SUNDRY NOTICES AND REPORTS ON WELLS

1. Type of Well ☐ Oil Well ☐ Gas Well ☒ Other Injection		5. Lease Serial No. NM-LC 06193614
2. Name of Operator OXY USA Inc. 16696		6. If Indian, Allottee or Tribe Name
3a. Address P.O. Box 50250 Midland, TX 79710	3b. Phone No. (include area code) 432-685-5717	7. If Unit or CA/Agreement, Name and/or No.
4. Location of Well (Footage, Sec., T., R., M., or Survey Description) 660 FSL 1980 FWL SESW(LN) Sec 10 T25S R32E		8. Well Name and No. Cotton Draw Unit # 19
		9. API Well No. 30-025-08175
		10. Field and Pool, or Exploratory Area Paduca Delaware
		11. County or Parish, State Lea NM

OXY USA Inc. - Proposed
Cotton Draw Unit #19
API No. 30-025-08175

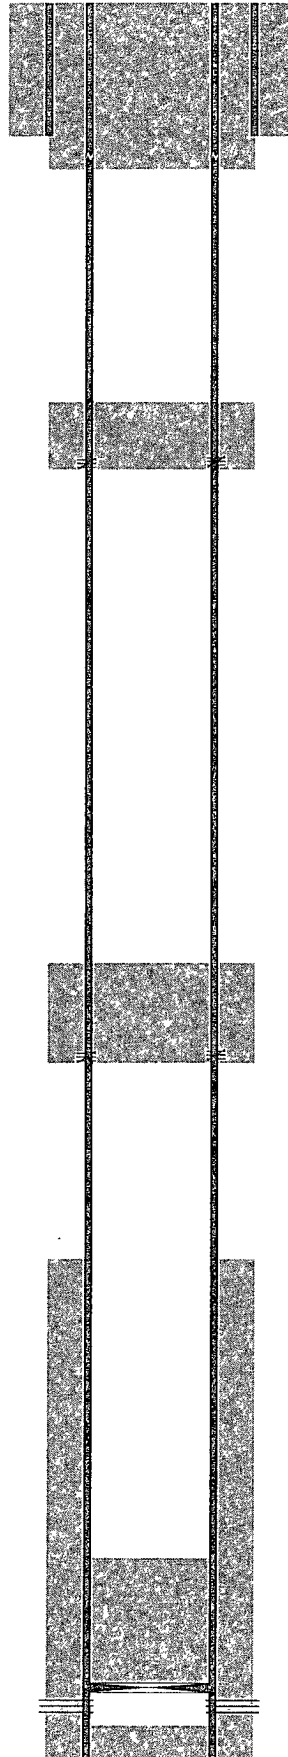
Perf 2890 SQZ Cmt To 2760
WOC Tag "Not Required"

Tag 4378 (B/salt)

WOC Tag 4378

SEE ATTACHED FOR
CONDITIONS OF APPROVAL

Ground Level Dry Hole Marker Required
